Item ID: D350-607-541 Accept ***N900040100*** Setup Start ***NS1***
Revision ID: Stop ***NS2***
Item Name: AS350/AS355 Quick Release Heli-Utility-Basket™ Long, Heavy Duty Lid
Start Date: 5/17/2017 Start Qty: 1.00 ***1*** Cust Item ID:
Required Date: 5/30/2017 Req'd Qty: 1.00 ***1*** Customer:
Reference: SCHEDULED/C

DART SERVICE INSTRUCTION

TO AMEND INSTALLATION INSTRUCTIONS D350-607-3 Rev.D,
INSTALLATION INSTRUCTIONS D350-607-4 Rev. C AND
INSTRUCTIONS FOR CONTINUED AIRWORTHINESS ICA-D350-607 REV. 6

A	NEW ISSUE	AJS	14.05.16
REV.	DESCRIPTION	BY	DATE
DESIGN	AJS	DART AEROSPACE LTD HAWKESBURY, ONTARIO, CANADA	
DRAWN	AJS		
CHECKED		DRAWING NO.	REV. A
MFG. APPR.	N/A	DSI 9699	SHEET 1 OF 2
APPROVED		TITLE	SCALE
DE APPR.		LUG REPLACEMENT	NTS
DATE	14.05.16	COPYRIGHT © 2014 BY DART AEROSPACE LTD THIS DOCUMENT IS PRIVATE AND CONFIDENTIAL AND IS SUPPLIED ON THE EXPRESS CONDITION THAT IT IS NOT TO BE USED FOR ANY PURPOSE OR COPIED OR COMMUNICATED TO ANY OTHER PERSON WITHOUT WRITTEN PERMISSION FROM DART AEROSPACE LTD.

FIGURE 1: INSTALLATION OF D4775-041 FWD STRUT

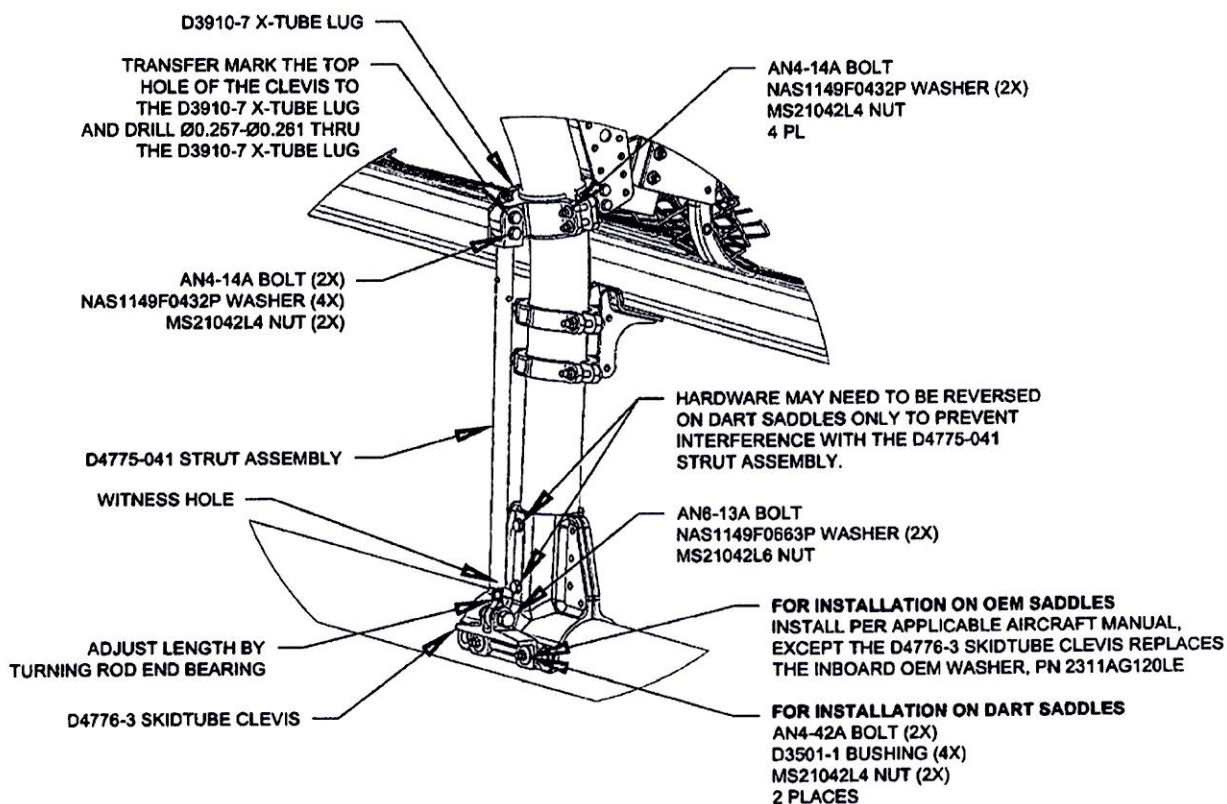
3.1 Substitute the Forward Lower D3910-5 X-Tube Lug with the D3910-7 X-Tube Lug as shown in Figure 1.

3.2 Install the forward D4775-041 Strut Assembly. Transfer mark from the upper hole on the clevis of the D4775-041 Strut Assembly to the D3910-7 X-tube Lug and drill thru the lug $\varnothing 0.257$ - $\varnothing 0.261$ as shown in Figure 1. Touch up chemical conversion coating per MIL-DTL-5541. Check the witness holes located at the bottom end of the D4775-041 Strut Assemblies to ensure that the thread from the rod end extends past the witness hole.
Torque MS21042L4/-4 nuts to 50-70 in-lbs (5.7-7.9 N-m). Torque MS21042L6/-6 nuts to 160-190 in-lbs (18.1-21.5 N-m).
